SINGAPORE CIVIL DEFENCE FORCE

AMENDMENTS TO FIRE CODE 2018 - 6th BATCH OF AMENDMENTS

SCDF would like to issue the 6th batch of amendments to the Code of Practice for Fire Precautions in Buildings 2018 (Fire Code 2018). The amendments which were deliberated and accepted by the Fire Code Review Committee are attached as Annex A, B & C of this circular.

Diagram 4.2.2i.(2) : Marking of fire engine accessway/fire engine access road

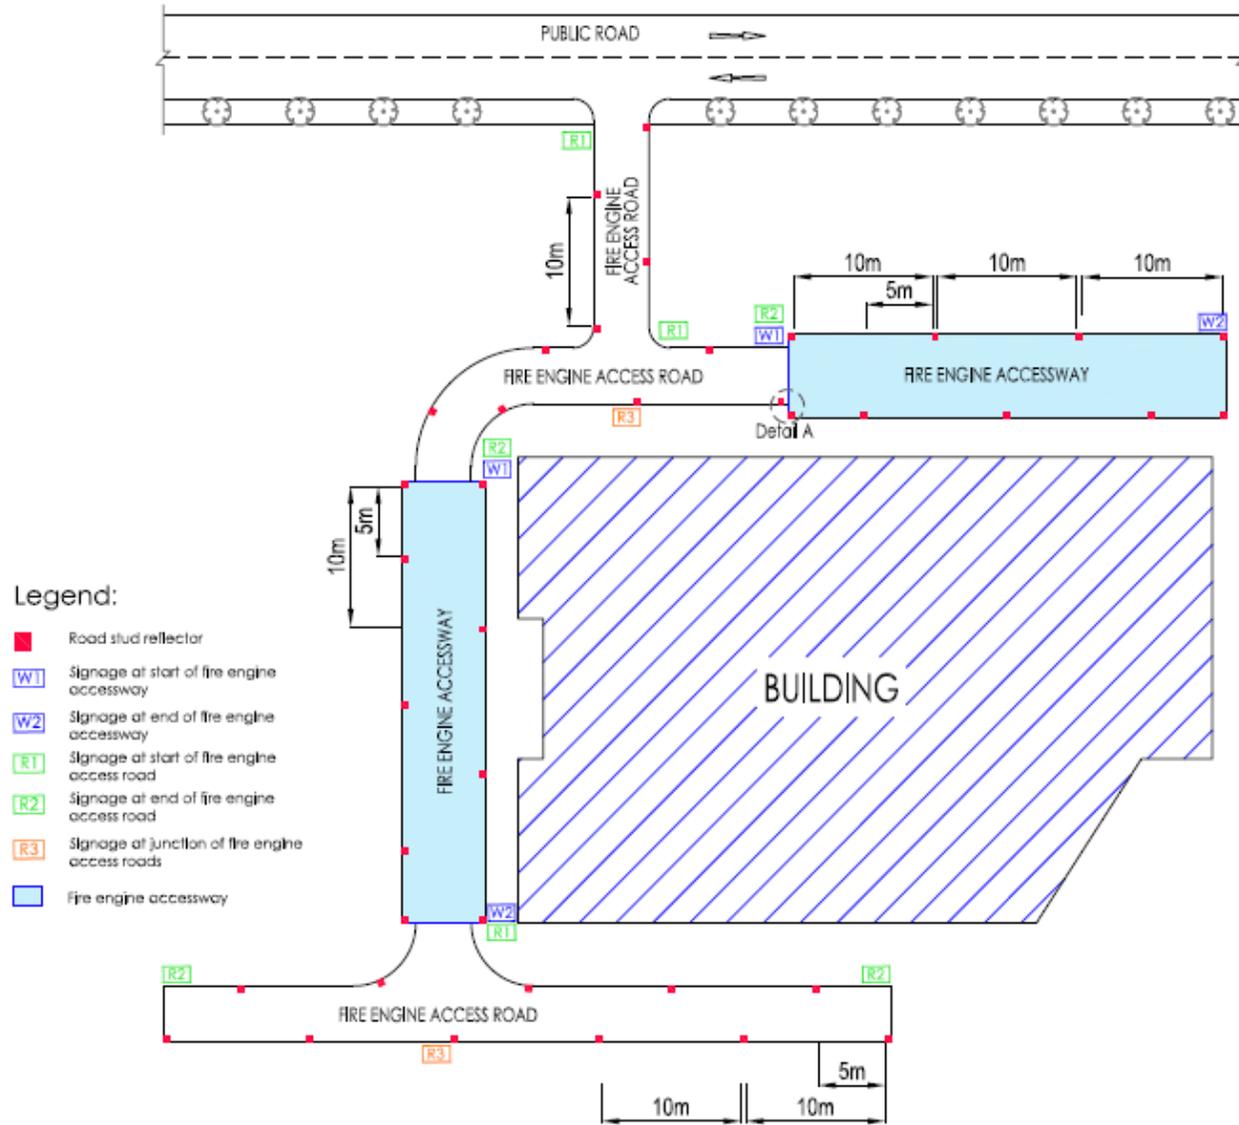
15	4.2.2i.	15 Sep 2020	15 Mar 2021	Revised	<p>Marking of fire engine accessway and fire engine access road</p> <p>(1) All corners of fire engine accessway/fire engine access road shall be marked, except where public roads are designated as fire engine accessway/fire engine access road.</p> <p>(2) Metalled/non-metalled or paved/non-paved surface fire engine accessways/fire engine access roads shall be marked with reflective white or yellow strips of size not less than 100mm (W) x 400mm (L). The markings shall be visible at night and shall be provided on both sides of the fire engine accessways/fire engine access roads at an interval of not more than 5m.</p> <p>(3) A sign post with white background and red wording of not less than 50mm in height shall be provided at the start and end of a fire engine accessway/fire engine access road. The height measured from the ground to the lowest point of the sign shall be</p>	<p>Marking of fire engine accessway and fire engine access road</p> <p>(1) All corners—of fire engine accessway/fire engine access road shall be marked, except where public roads are designated as fire engine accessway/fire engine access road.</p> <p>(2) Metalled/non-metalled or paved/non-paved surface fire engine accessways/fire engine access roads shall be marked with reflective white or yellow strips of size not less than 100mm (W) x 400mm (L), or white or yellow road stud reflectors of size not less than 100mm (W) x 100mm (L) x 18mm (H). The markings or reflectors shall be visible at all times night and shall be provided on both sides of the fire engine accessways/fire engine access roads at an alternate interval of not more than 5m. Markings or reflectors shall also mark all corners and turning corners of the fire engine accessway. See Diagram 4.2.2i.(2).</p>

Diagram 4.2.2i.(3) : Pictogram signage for fire engine accessway/fire engine access road

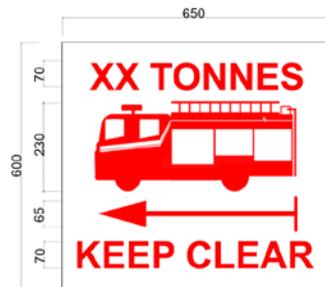
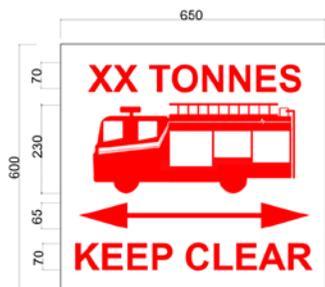
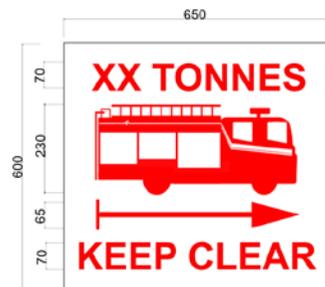
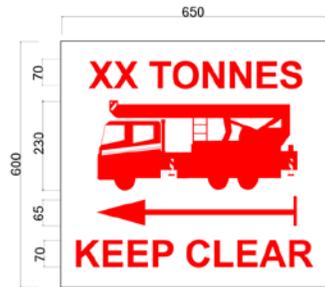
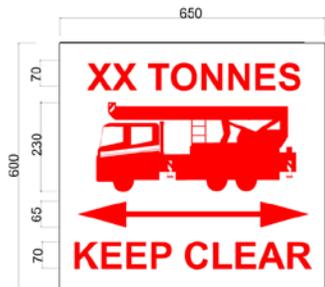
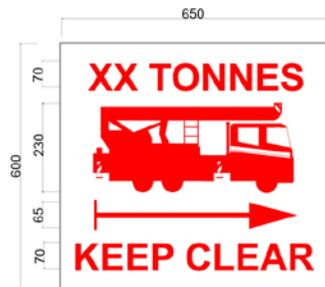
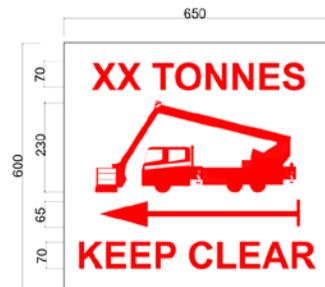
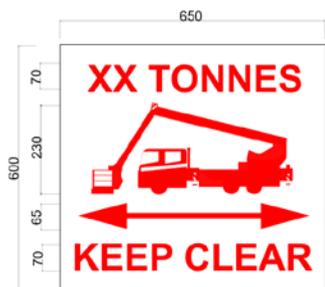
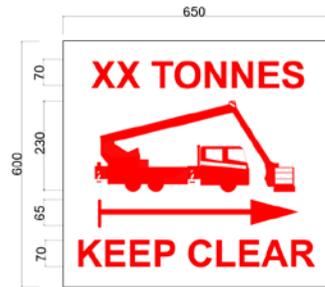
<p>between 2m and 2.2m. The sign post shall be visible at night and shall not be positioned more than 3m from the fire engine accessway/fire engine access road. Every part of the fire engine accessway/fire engine access road shall not be more than 15m from the nearest sign post. See <i>Diagram 4.2.2i.(3)</i>.</p>	<p>(3) A sign post with white background and red pictogram with upper case wording of not less than 50mm 70mm in height shall be provided at the start, junction, and end of a fire engine accessway/fire engine access road. The height measured from the ground to the lowest point of the sign shall be between 2m and 2.2m 2.3m and 2.4m. The sign post shall be reflective, visible and unobstructed at all times at night and shall not be positioned adjacent to more than 3m from the fire engine accessway/fire engine access road. Every part of the fire engine accessway/fire engine access road shall not be more than 15m from the nearest sign post. For locations where there are more than one of such signs, the signs can be placed on the same post. See <i>Diagram 4.2.2i.(3)</i>.</p>
